Application for URBAN DESIGN COMMITTEE Review

Project Name: Emergency Communication Center - Expansion and Alterations

Re: Conceptual Review
Richmond Emergency Communications Center
Expansion and Renovations

2 NORTH ELEVATION
SCALE: 1/8" = 1'-0"

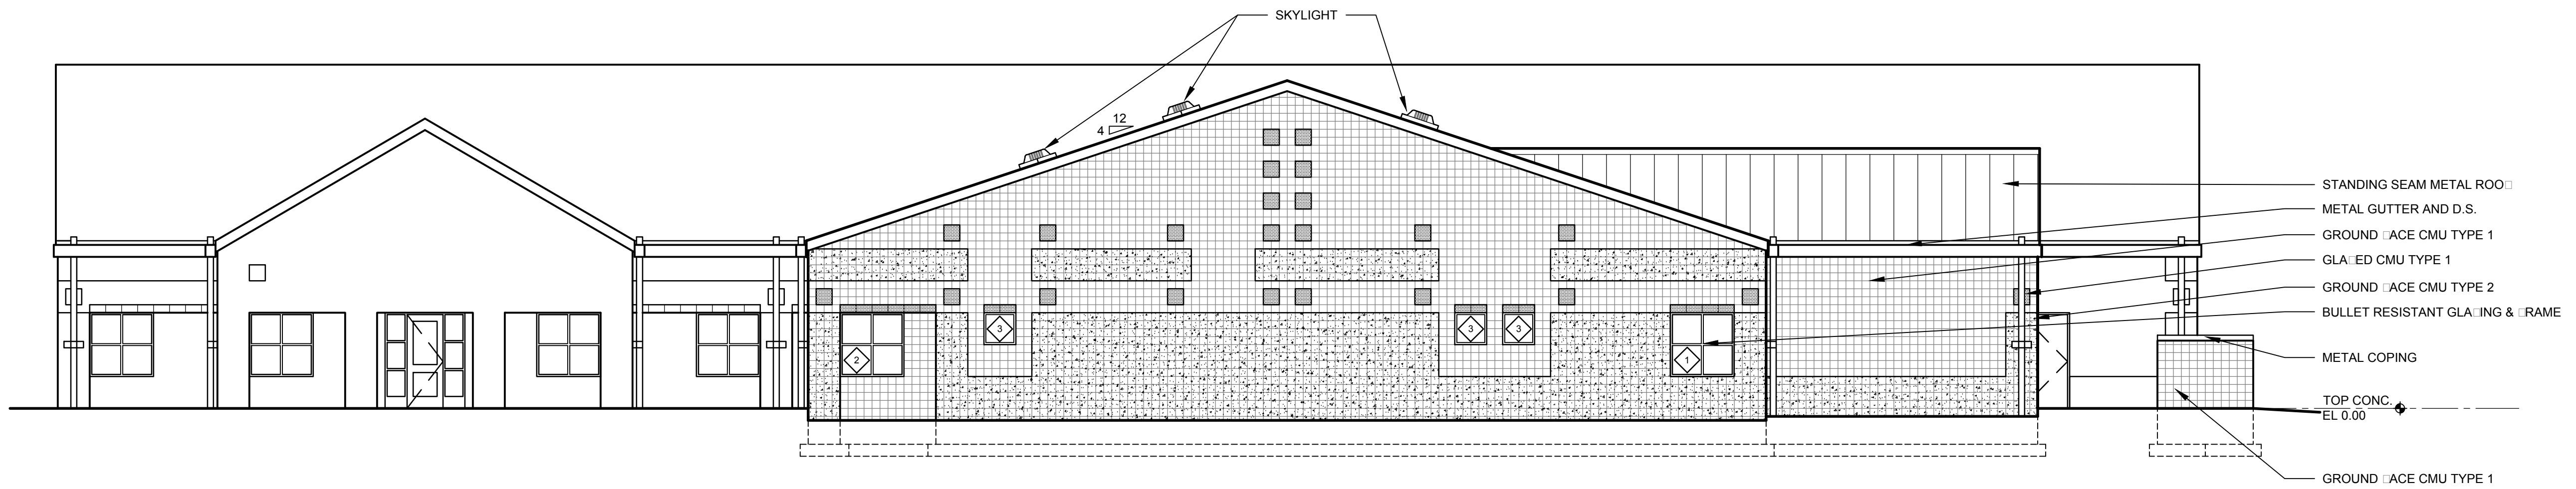
The previous review comments included the recommendation for additional windows on the north façade. Four windows have been added to the north elevation where conference rooms and offices provide an additional security barrier to the operations center and help maintain the low light levels preferred by Dispatchers and Call-Takers.
